UNITED STATES
NUCLEAR REGULATORY COMMISSION
WASHINGTON, D. C. 20555

SUBJECT: DAILY STAFF NOTES, JANUARY 5, 1981

Re: CONSUMERS POWER COMPANY
(Midland Plant, Units 1 and 2)
Docket Nos. 50-329 and 50-330
(Operating Licenses Proceeding)

10-16-77 ISSUED FOR FIELD USE		50% ^{AD} JGK		JGK/10/5/200/2.	
No.	DATE	REVISIONS		BY	CHK	APPD	
OWNER		 CONSUMERS POWER COMPANY MIDLAND PLANTS UNITS 1 AND 2 MIDLAND, MICHIGAN		JOB No 7220			
BAPC				SPEC/DES GUIDE No		REV	
				7220-C-94(Q)		0

FIGURE 1

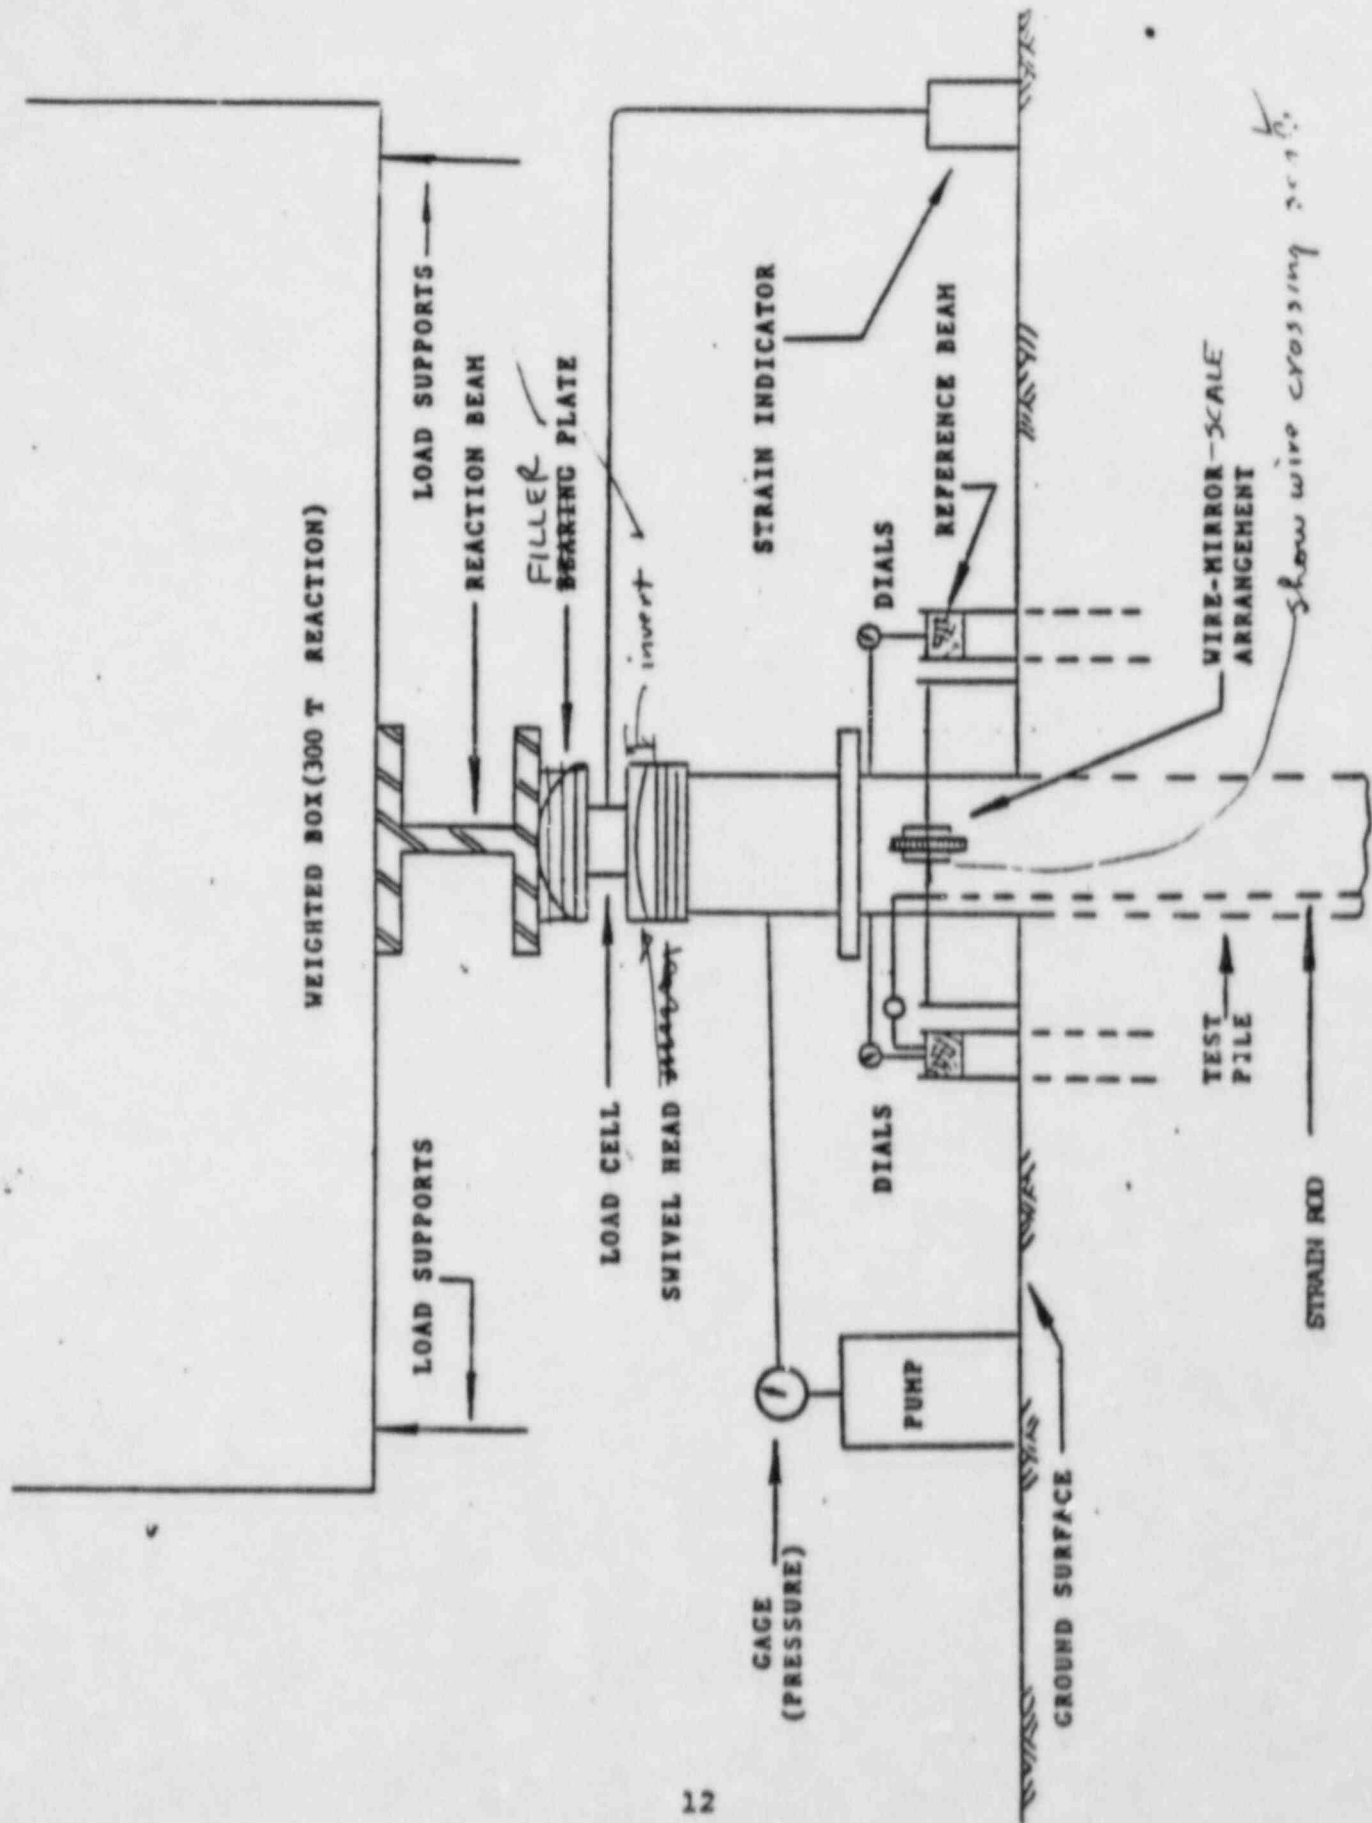
Must be sure that pipe can be obtained long enough without splices. Splice in test pile is OK. Delete 1st 3 words. What is "Splicing steel". Delete 1st 3 words. What are they - m.l.t. 5.2.1

Delete 6.2 You cannot specify pile & tell it how it behaves - Must accept the result.

delete.
580 ft
TOP of stratum
USE TOP ELEV

FIGURE 2 LOAD TEST

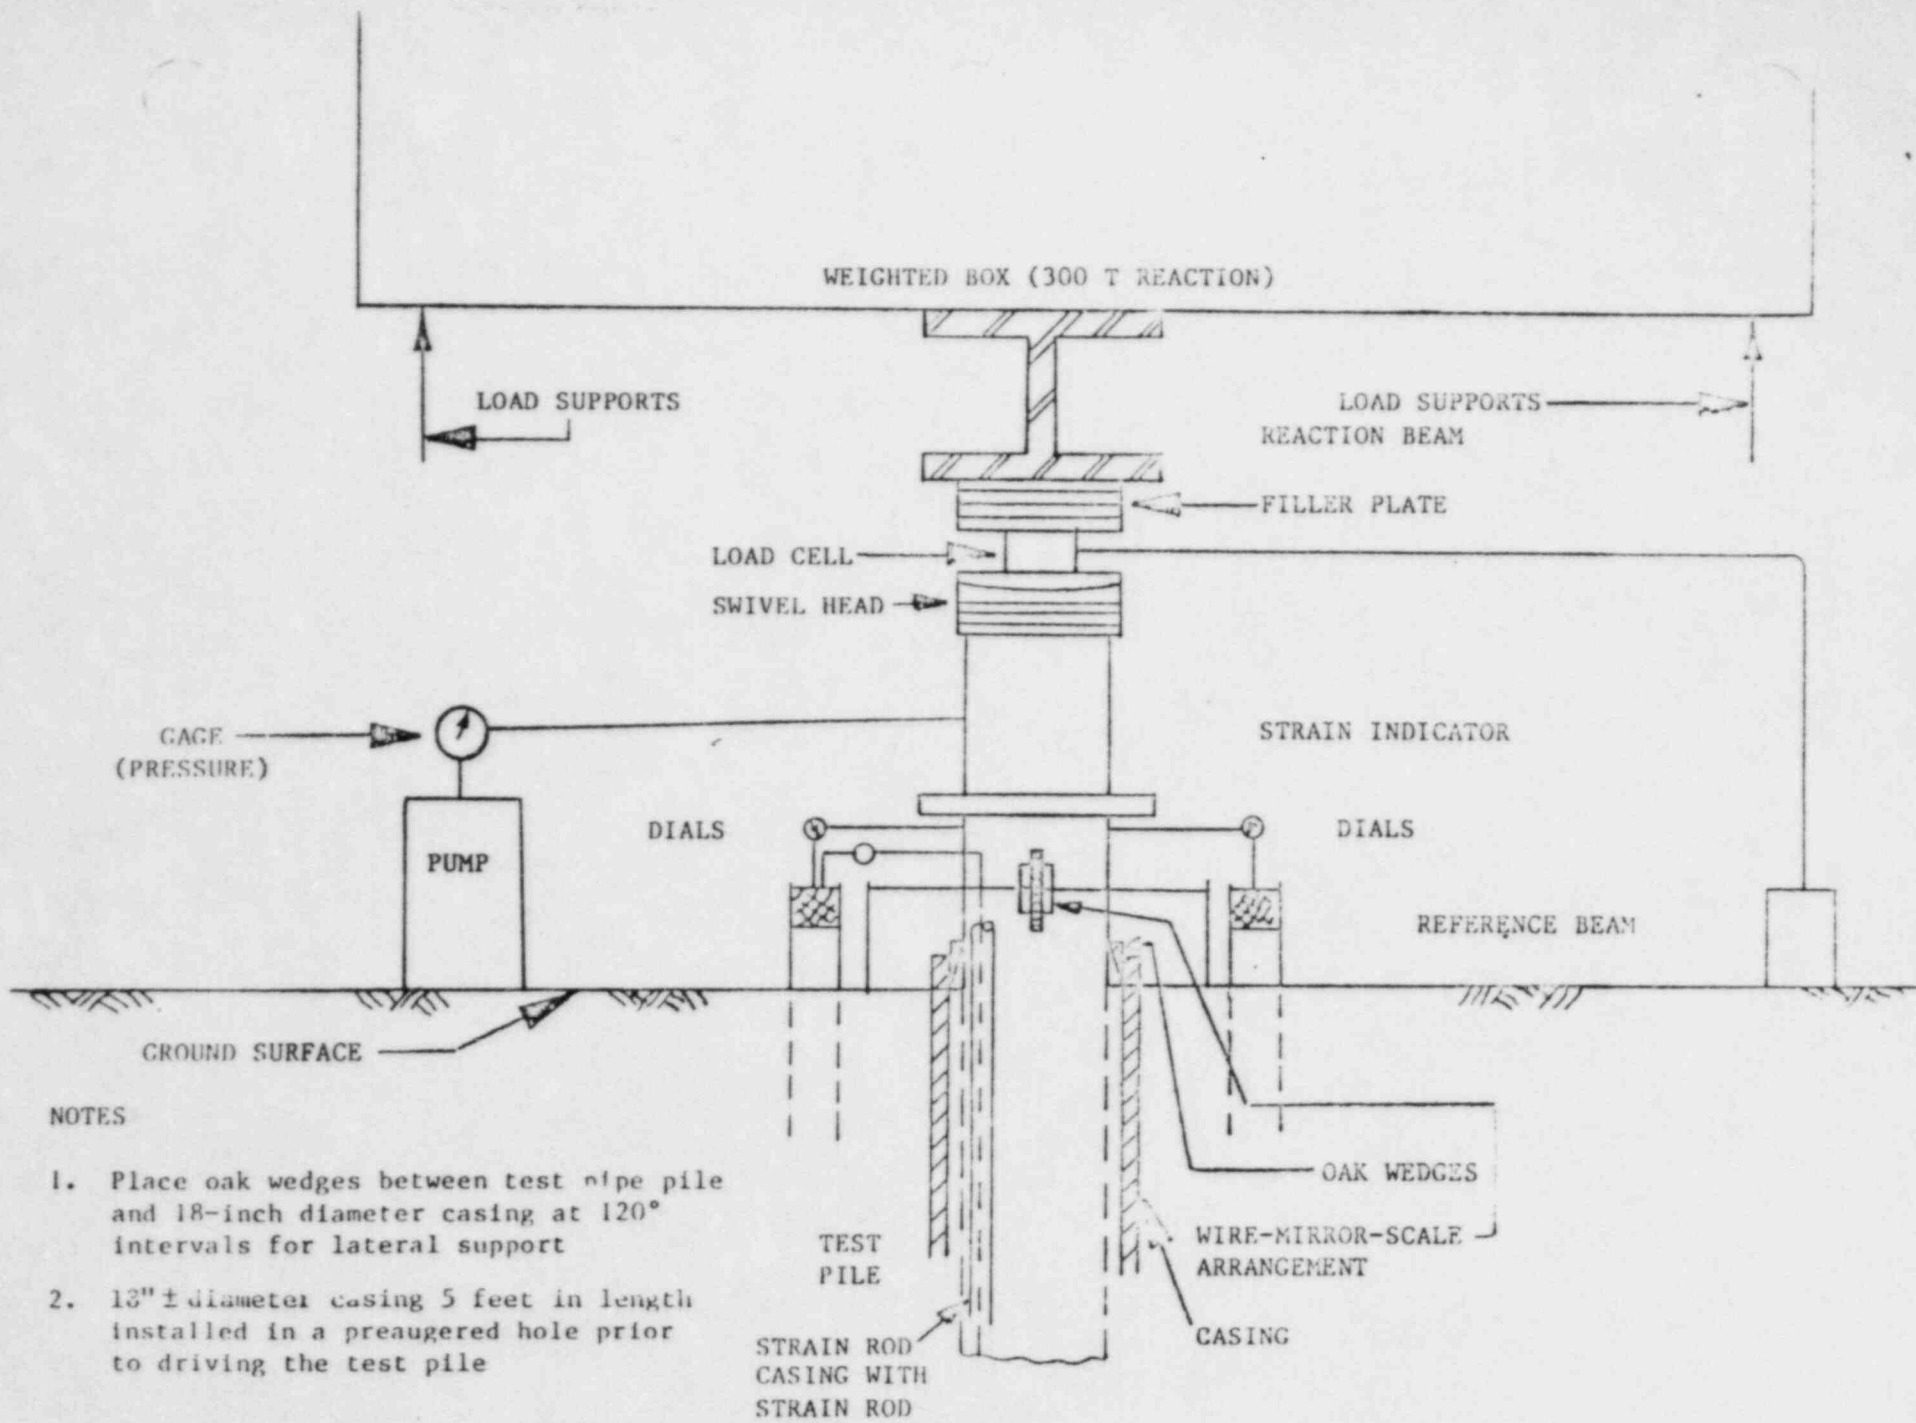
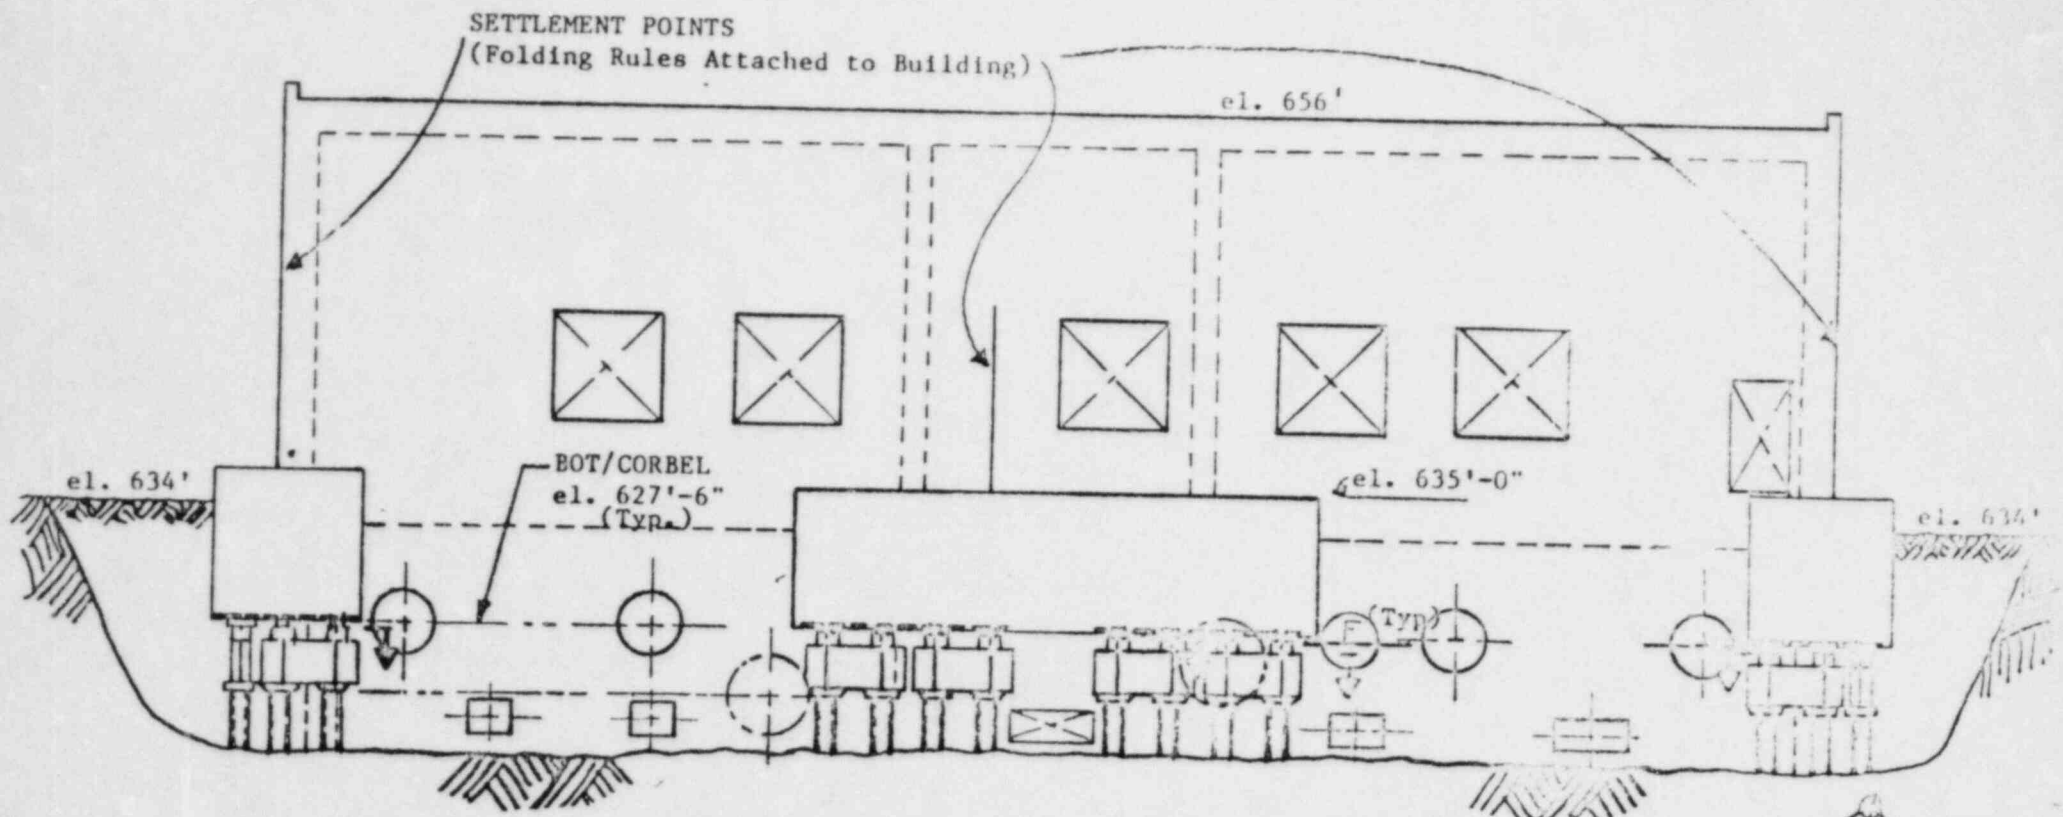
test to 210T - 110T - 210T - 110T - 210T - 110T - 210T
 0 210 0 210 0 210
 continue to 390T max hold 2 hrs.
 revise to 7 cycles

*Add
NSF 700T
@ 5T increments*
